SDG&E Comments on the CAISO 2018-2019 Transmission Plan (February 28, 2019)

Submitted by	Organization	Date Submitted
<i>John Jontry</i>	<i>San Diego Gas & Electric</i>	<i>February 28, 2019</i>
<i>Jan Strack</i>		
<i>Habib Maiga</i>

SDG&E's Approach of evaluating capacity benefits

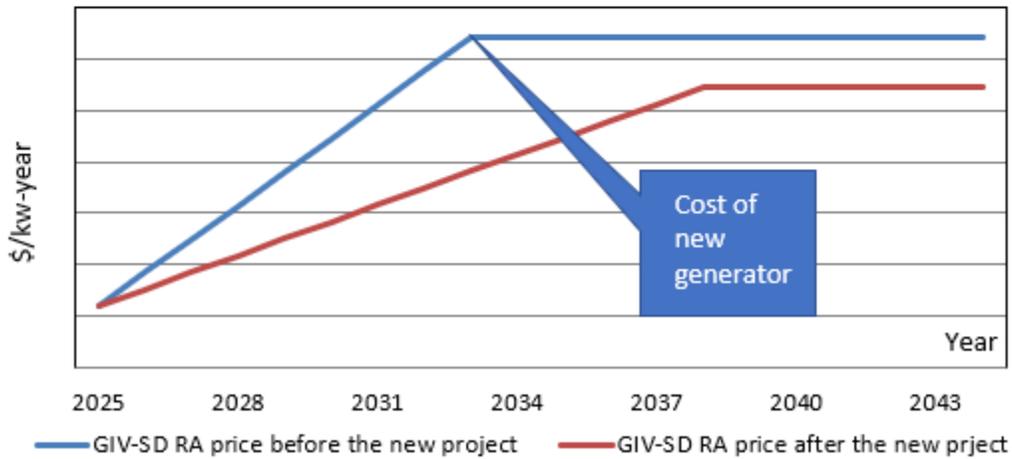
Specifically, SDG&E’s proposed approach is to forecast longer term (corresponding to asset lives of 50 or more years) capacity prices by considering resource scarcities over time, the cost of building new generators that will comply with California’s policies (e.g. SB100) including the replacement of such generation when their useful economic lives end, and the impact of future technology improvements on zero-carbon resources’ costs (e.g. storage). The graph below illustrates such a methodology:

SDG&E notes that important studies by the CAISO have been previously conducted using the approach proposed by SDG&E in these comments. SDG&E is unclear why, in the current transmission planning cycle, the CAISO has chosen to use a different approach for forecasting long-term RA capacity prices. Frequent changes to the LCR reduction benefit methodology creates uncertainties and difficulties for stakeholders working on potential LCR reduction projects.
